Subject: Pacific Gas & Electric's Colusa Generating Station Project (06-AFC-9C)
License Petition Amendment #2

Colusa Generating Station

Amendment 2

FIGURE 1
SITE LAYOUT AND LINEAR FACILITIES
COLUSA GENERATING STATION
PACIFIC GAS AND ELECTRIC

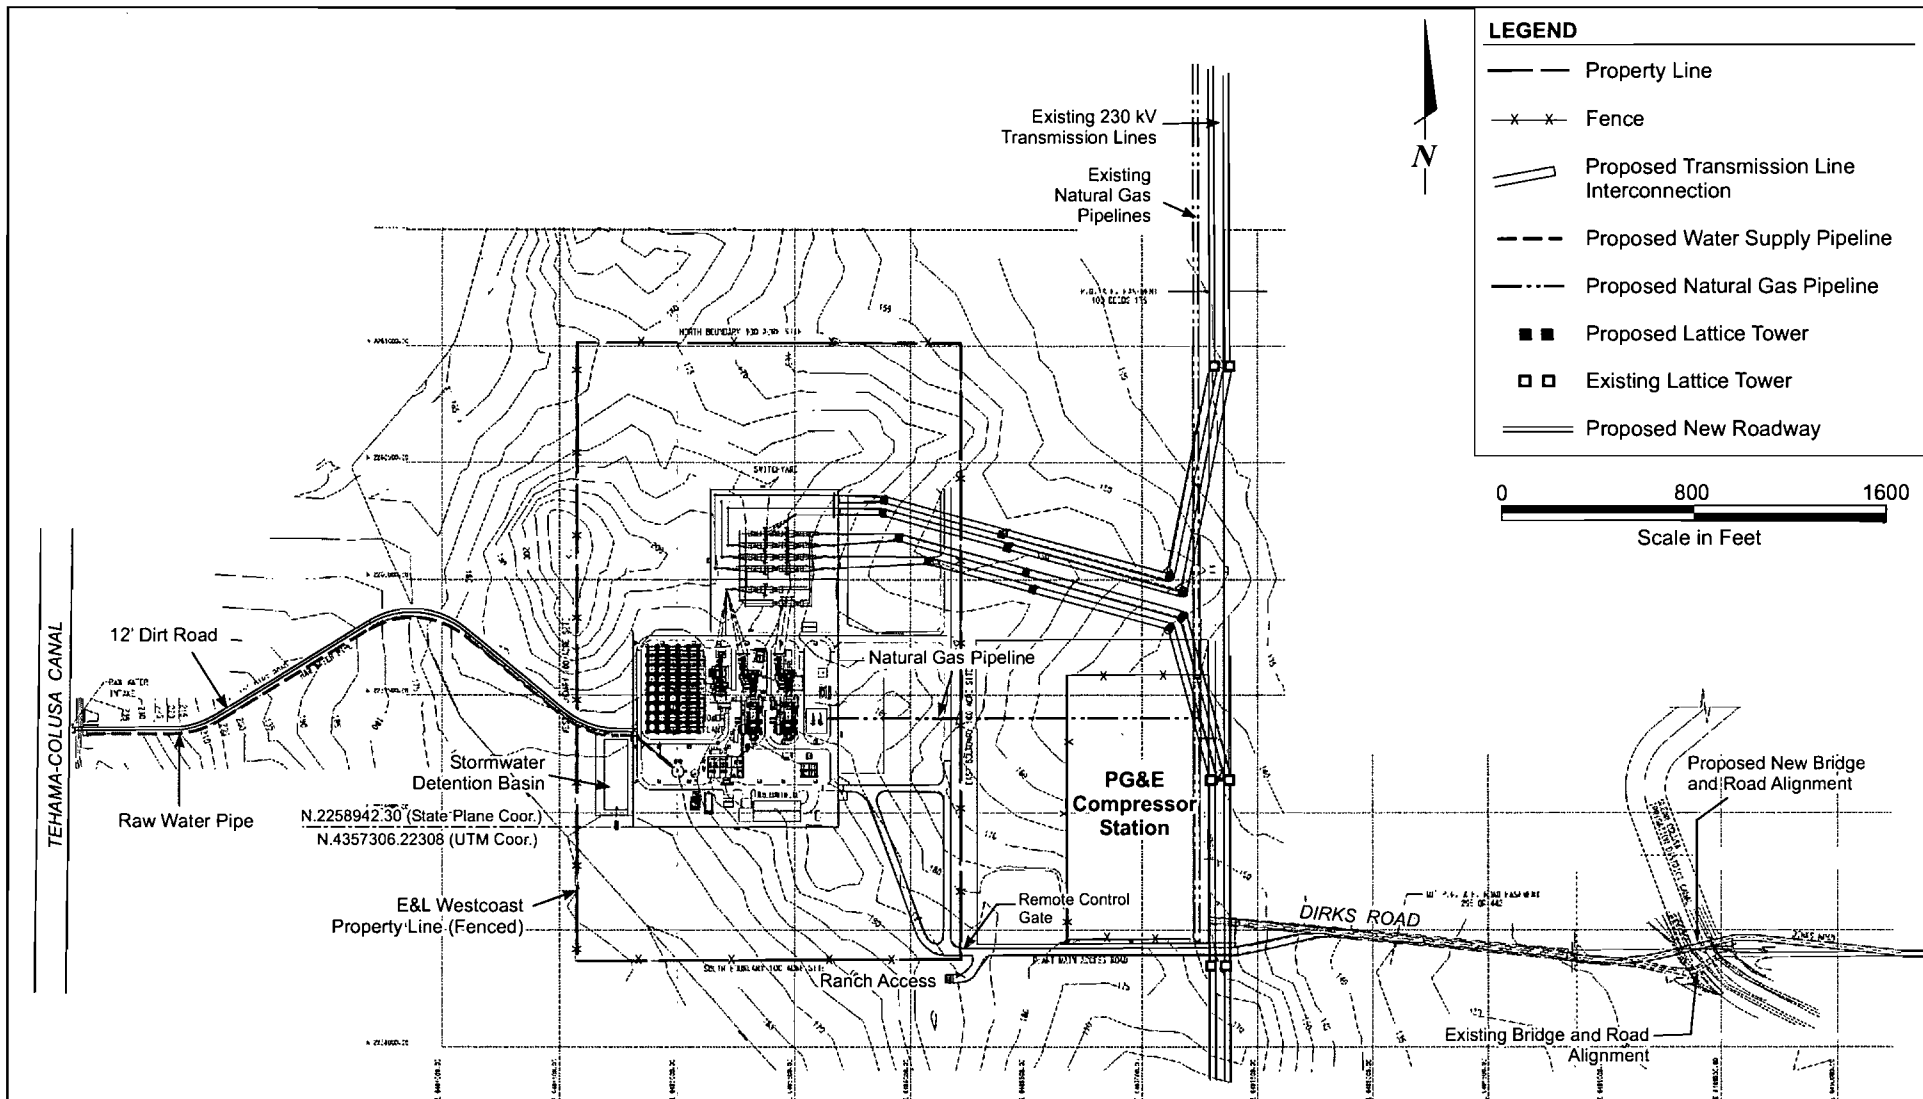
The CEC Final Decision also approved a total of eight new circuits to be constructed between the new switchyard and the adjacent PG&E transmission corridor – four circuits in and four circuits out. Two circuits are carried on each tower line, so there will be four tower lines connecting the switchyard to the electric transmission corridor. The original plan called for 12 new double-circuit, lattice steel transmission towers to be installed to accommodate both the looping of the 230-kV lines into the plant switchyard and for the connections from the generator step-up transformers to the switchyard. Figure 1 shows the location of the four double-circuit lines and the transmission tower locations that were approved in the Final Decision for the CGS Project.

FIGURE 2
TRANSMISSION LINE REROUTE AND SWITCHYARD MODIFICATIONS
 COLUSA GENERATING STATION
 PACIFIC GAS AND ELECTRIC

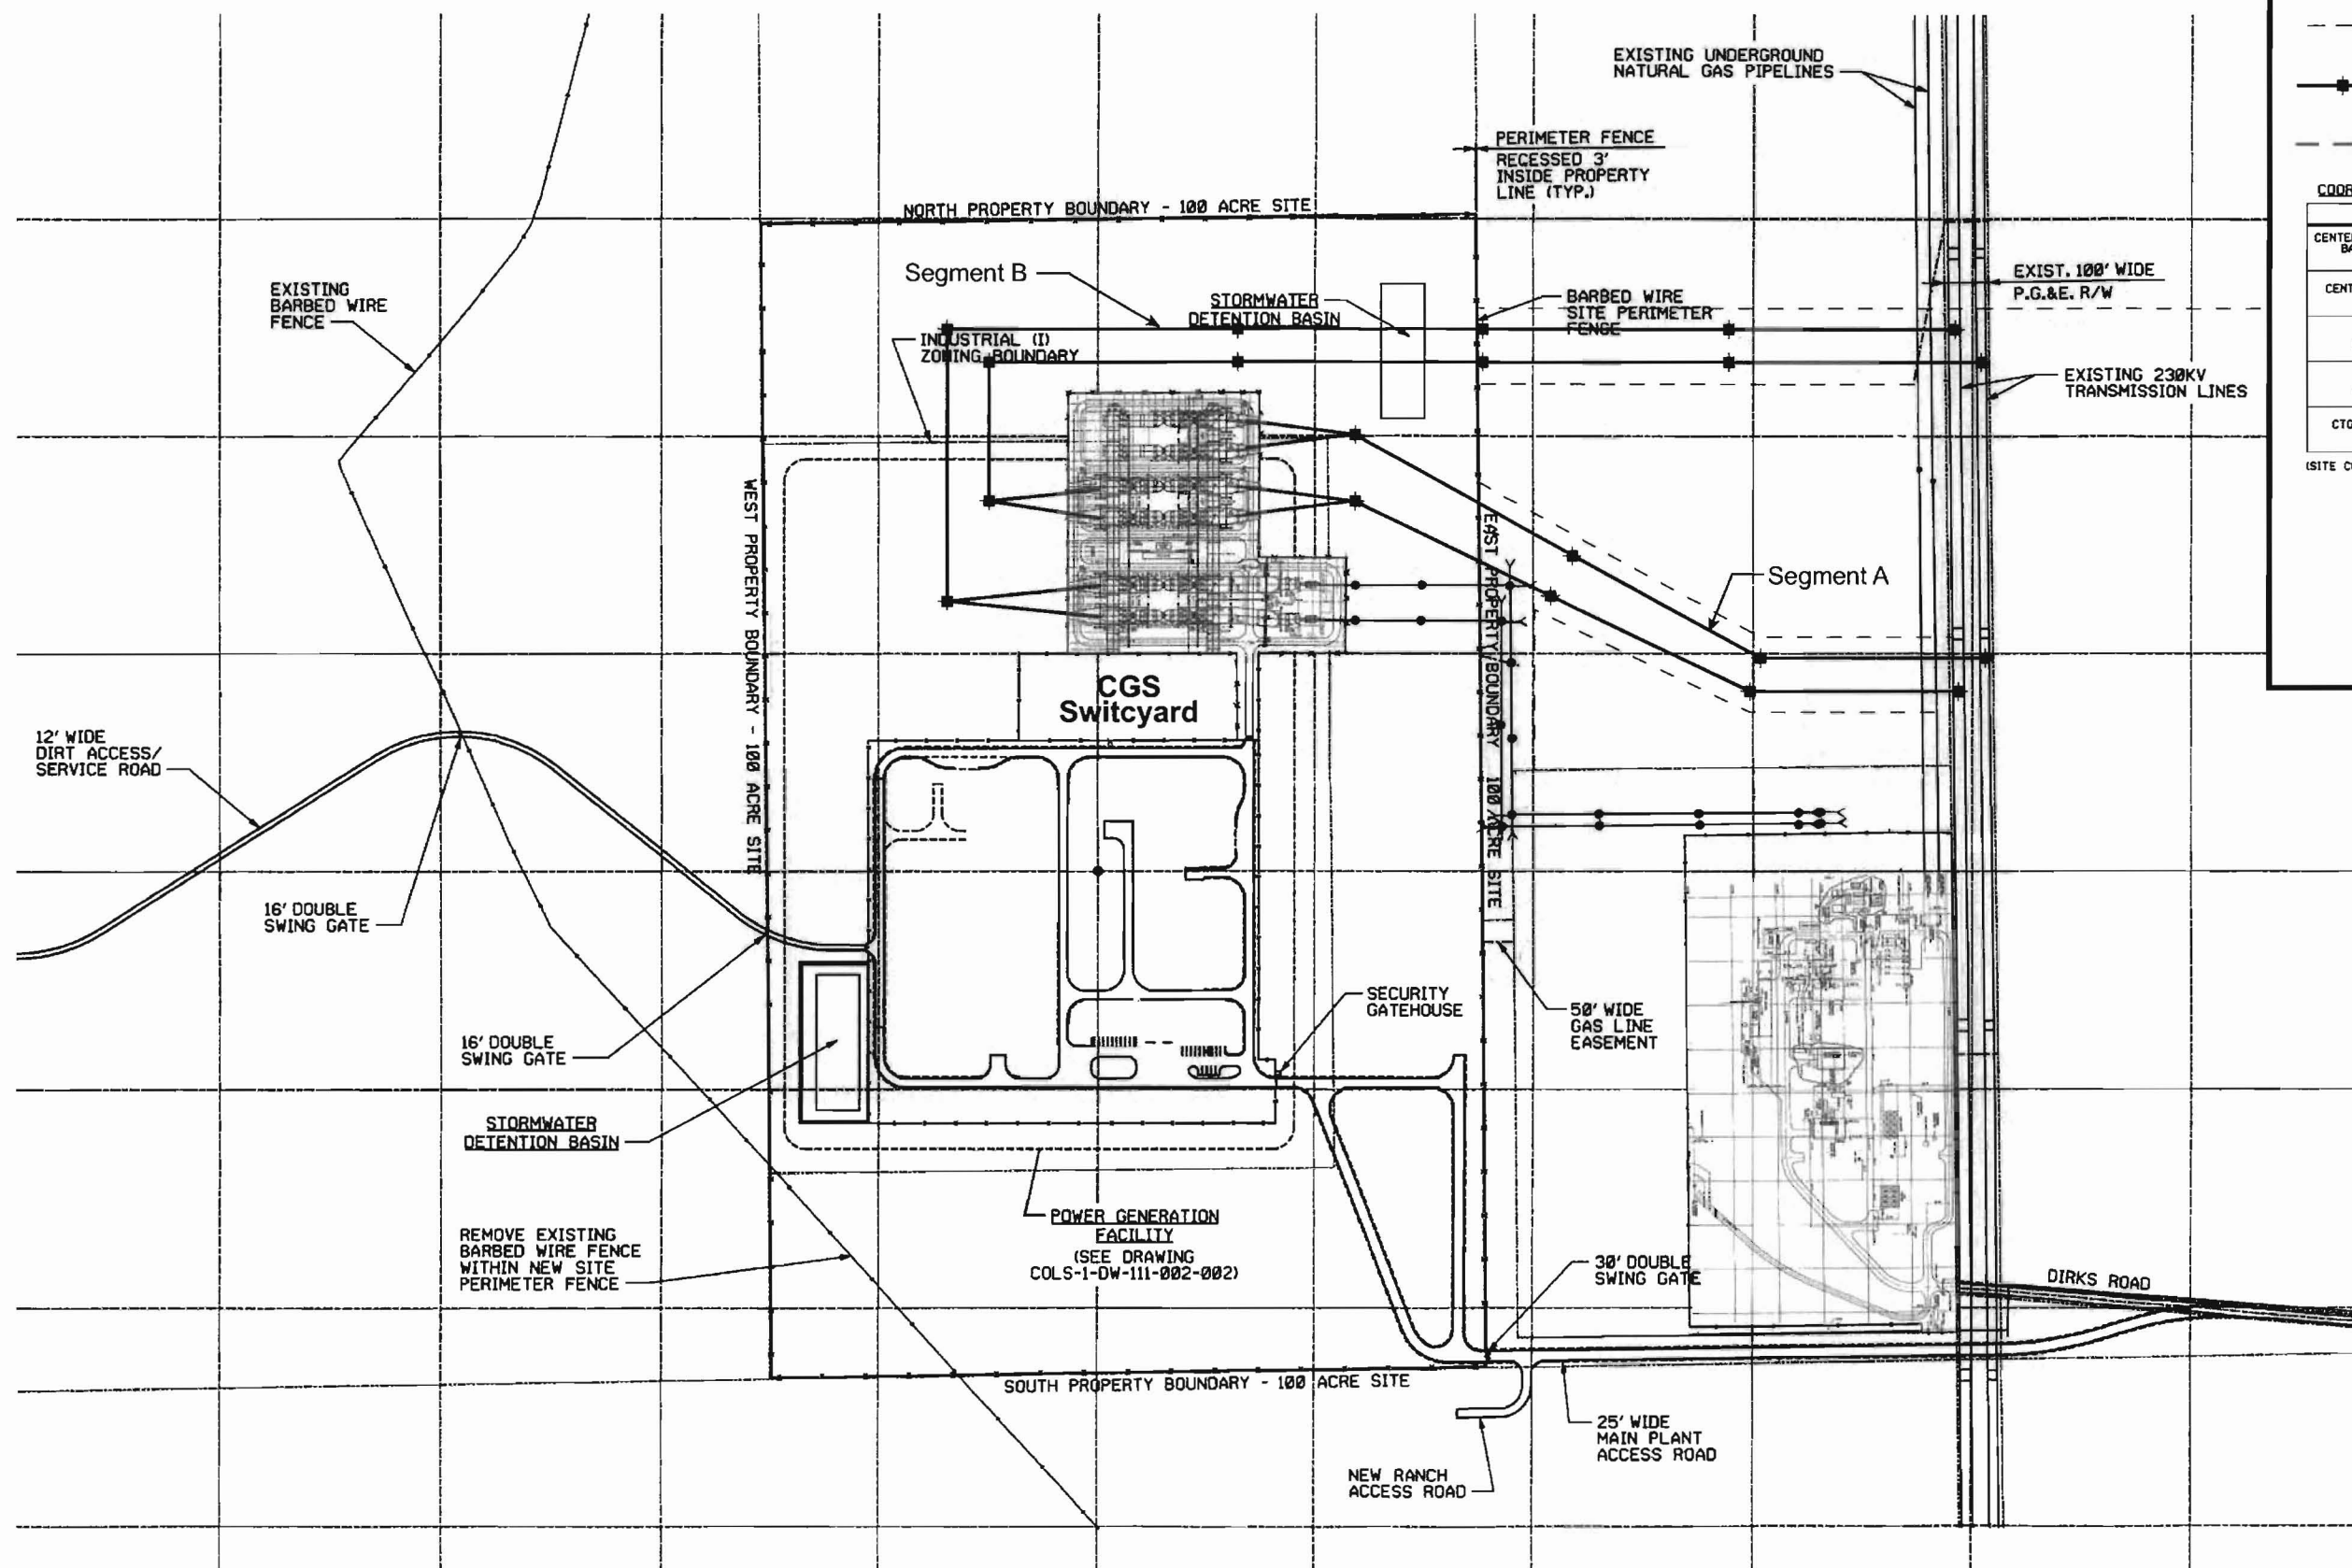
Modification of the switchyard/substation layout has necessitated some changes to the alignment of the approved transmission interconnection (see Figure 2). The CEC Final Decision approved a total of 12 new towers, four on site (within the 100-acre parcel) and eight off site. Under the new design, a total of 20 new towers will be constructed, with eight on site and 12 off site. The following paragraphs describe the proposed changes in more detail.

The southernmost transmission lines (Segment A) will interconnect with the existing transmission corridor following an alignment similar to that approved in the CEC Final Decision, but will avoid crossing over the northeast corner of the existing Delevan gas compressor station (PG&E's design criteria prohibits the siting of high voltage electric lines over gas yards). In order to properly connect the new line with the existing PG&E Cottonwood to Vaca-Dixon 230-kV transmission corridor, PG&E will add two additional transmission towers using the same lattice steel design approved by the CEC in the Final Decision, and remove two of the existing 230-kV transmission towers for a net increase of two new towers for this segment.

The two northern lines (Segment B on Figure 2) will also be realigned, requiring a total of 12 transmission towers. The new switchyard design requires that the lines exit the west side of the new switchyard rather than the east side as originally approved in the CEC Final Decision. After exiting the west side of the switchyard, the alignment will turn immediately north and then east to intersect with the existing transmission corridor. In order to support the revised alignment associated with Segment B, PG&E will need to construct six additional new transmission towers using the same lattice steel design approved by the CEC in the Final Decision. Six of these additional towers are located within the 100-acre construction site (only two of the towers in the CEC-approved design were located within this area). The other six transmission towers will be located in an alignment similar to that approved by the CEC except that the alignment eliminates a significant jog to the north. The overall length of Segment B is 2,850 feet compared to 1,800 feet as approved in the Final Decision.

The transmission towers located outside the 100-acre construction site will be placed approximately every 500 feet within a temporary 100-foot-wide construction easement. The temporary disturbance area associated with the six additional towers is 60,000 square feet and the permanent disturbance area will be 9,600 square feet. Construction of the new towers has the potential to slightly increase permanent impacts to Swainson's hawk foraging habitat. These impacts are discussed in Section 3.
